Re: Minor Project Refinement No. 5 for the South Orange County Reliability Enhancement Project.

ATTACHMENT A
MPR-5 Form

South Orange County Reliability Enhancement Project CPUC Minor Project Refinement Form

**MPR-5 Figure 1
Structure Location 10**

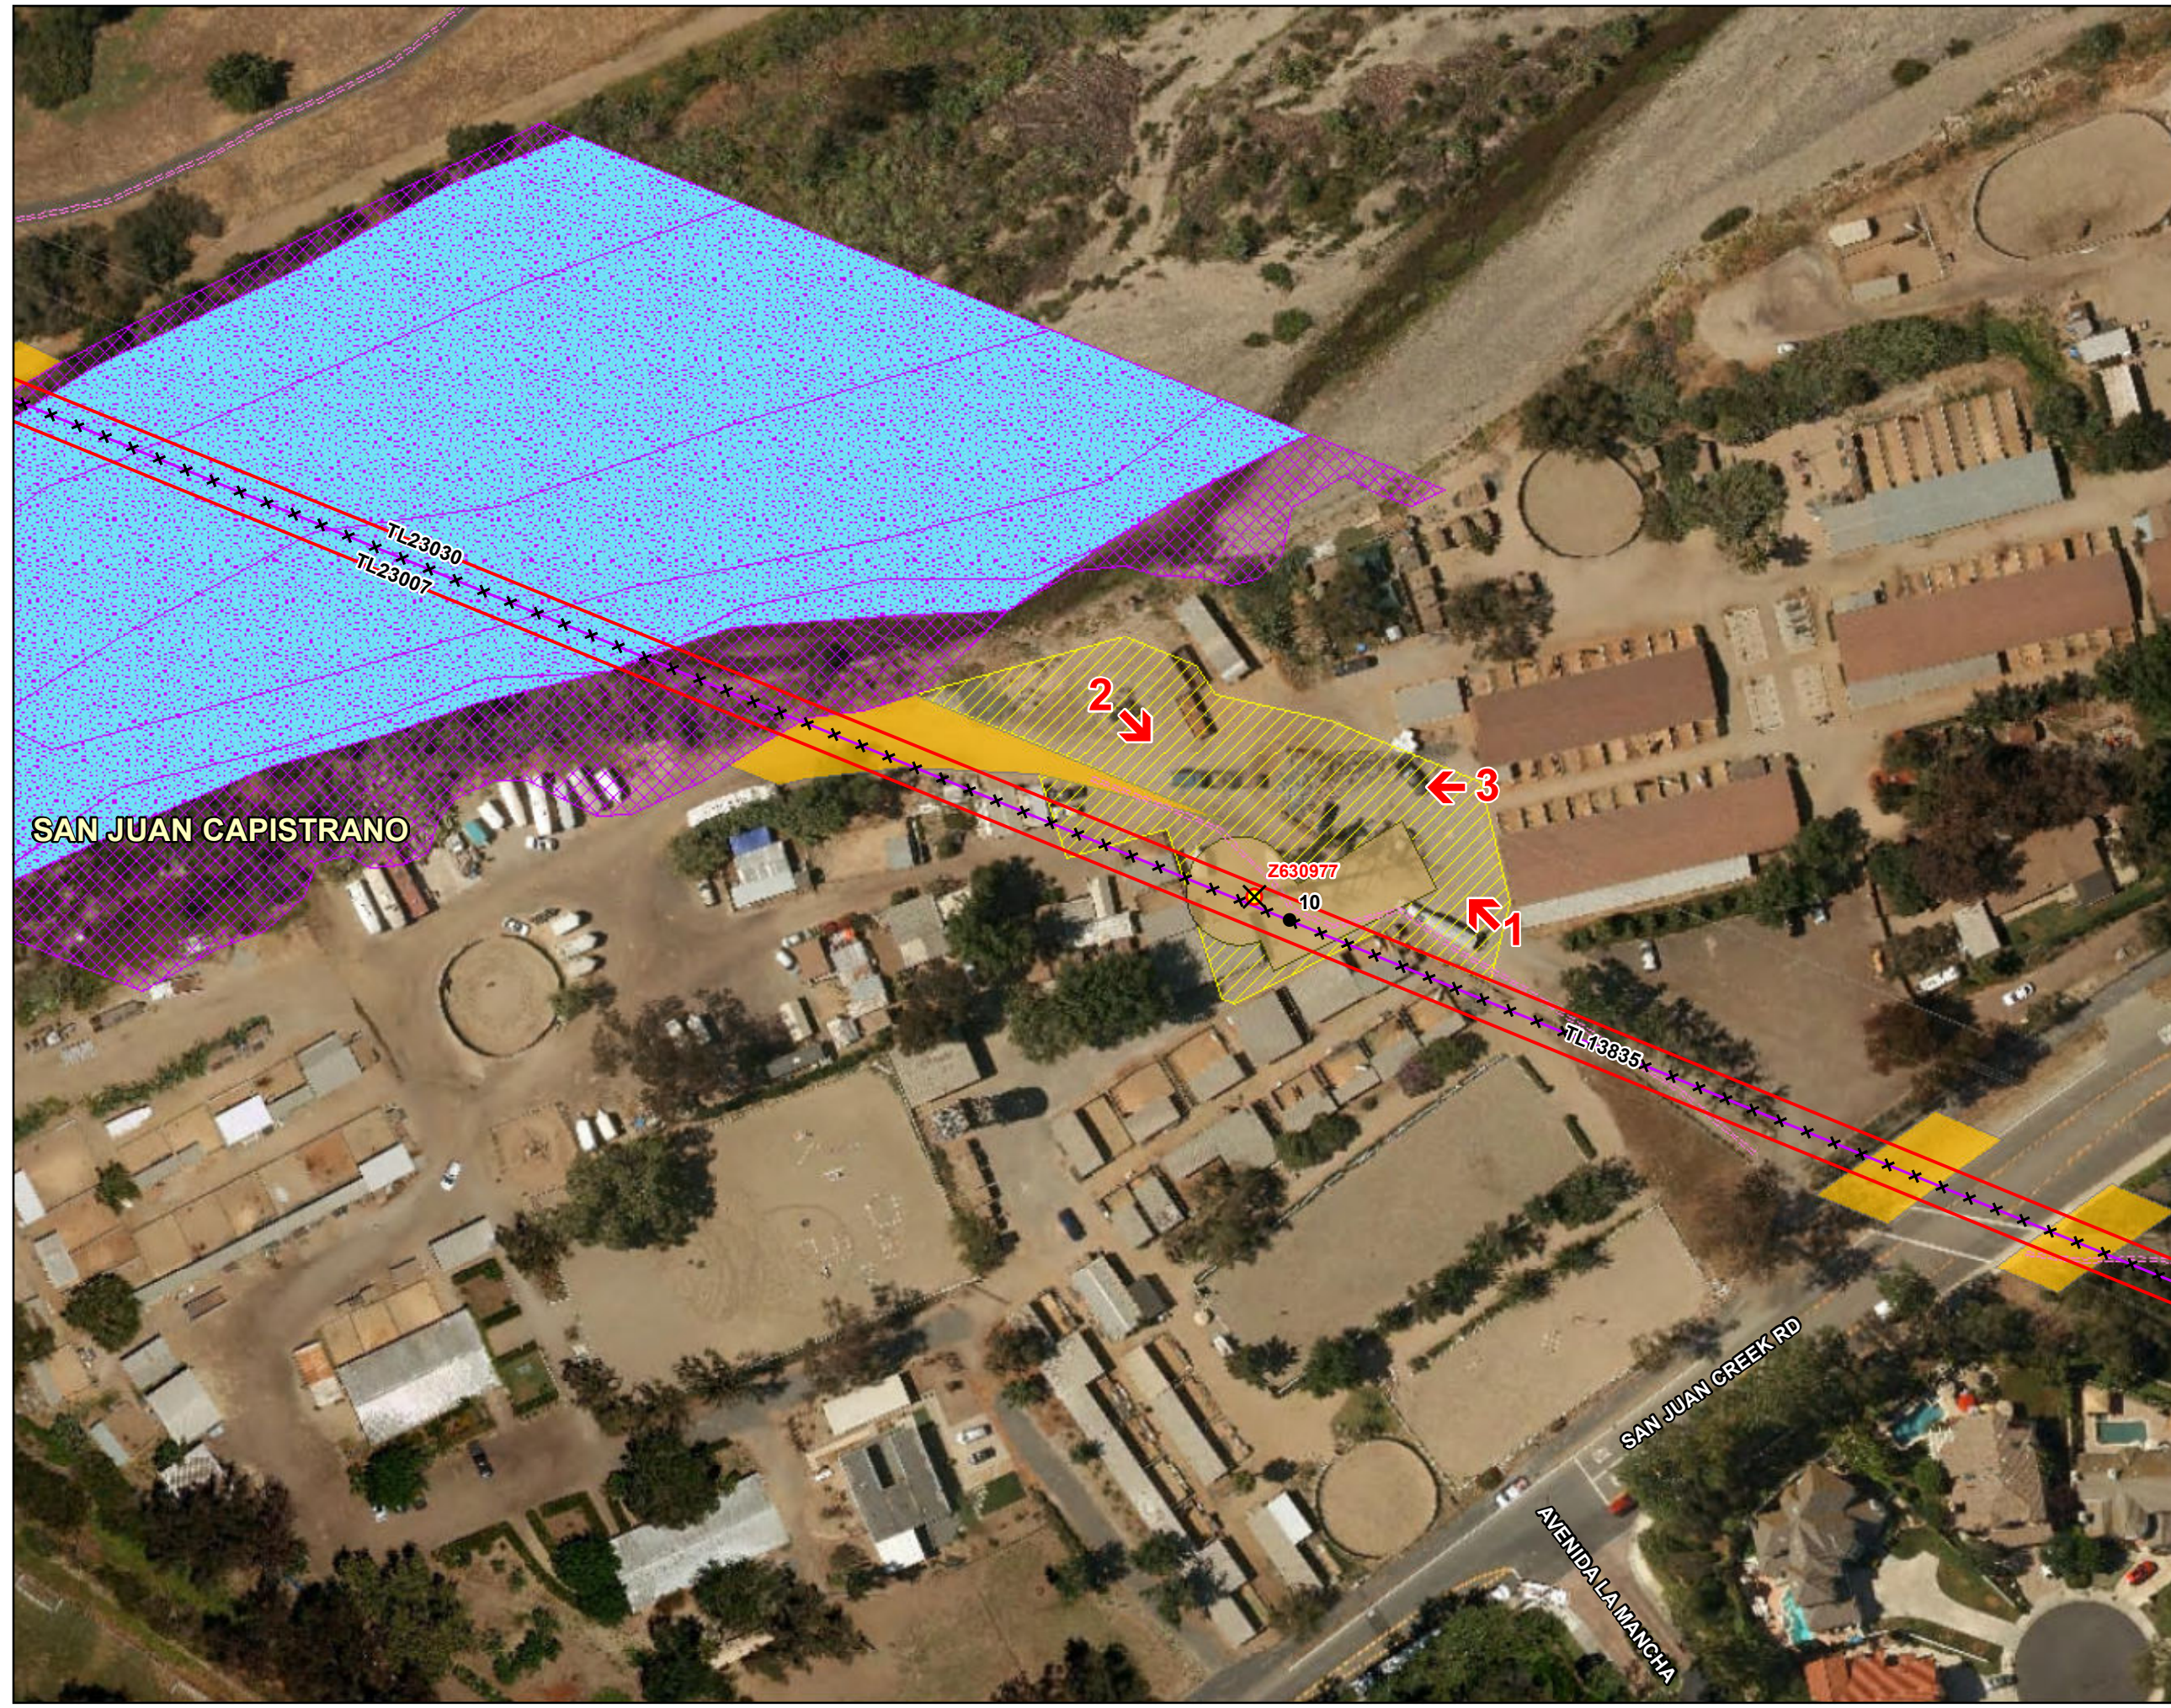
San Diego Gas and Electric (SDG&E) is requesting approval of MPR-5 for a new temporary work area required to facilitate construction of Location 10 for the South Orange County Reliability Enhancement Project (SOCRE or Project). The new temporary work area surrounds the existing work area for Location 10 and existing pole Z630977, previously approved in Notice to Proceed No. 6 (NTP-6) at Tar Farms Stables. The new MPR-5 work area will total approximately 22,026 square feet (0.5 acre).

The MPR-5 work area will be used for temporary materials and equipment laydown and will provide additional space to be used for drilling, hauling, concrete and crane operations associated with Location 10 construction. The additional work area will also allow adequate space for equipment to safely park and maneuver during Location 10 installation activities. No ground-disturbing activities will take place within the MPR-5 work area. There will be no trees or vegetation removed within the MPR-5 work area. And, no horse stables or other structures will be removed within the MPR-5 work area. The MPR-5 work area will be utilized for approximately 3 months and activities will begin immediately following MPR-5 approval. Following the use of the MPR-5 temporary work area, the area will be restored to pre-Project conditions based on pre-Project photo documentation by SDG&E, and in coordination with Tar Farms Stables. **Attachment B, MPR-5 Figure** shows the location of the MPR-5 temporary work area.

Maps & Figures: Refer to **Attachment B, MPR-5 Figure**, for a map of the proposed MPR-5 temporary work area location, which includes the direction of the point of view for each picture included in **Attachment C, MPR-5 Site Photographs**, for pictures of the current conditions within the MPR-5 temporary work area.

COA-1. The extent of the MPR-5 additional work area will be limited to the area shown on the figure titled "SOCRE PROJECT, MPR-5 Figure 1, Structure Location 10", and will be used only for temporary laydown of materials and equipment and to provide additional space for drilling and crane operations associated with Location 10 construction. MPR-5 activities will only occur within the SDG&E right-of-way.
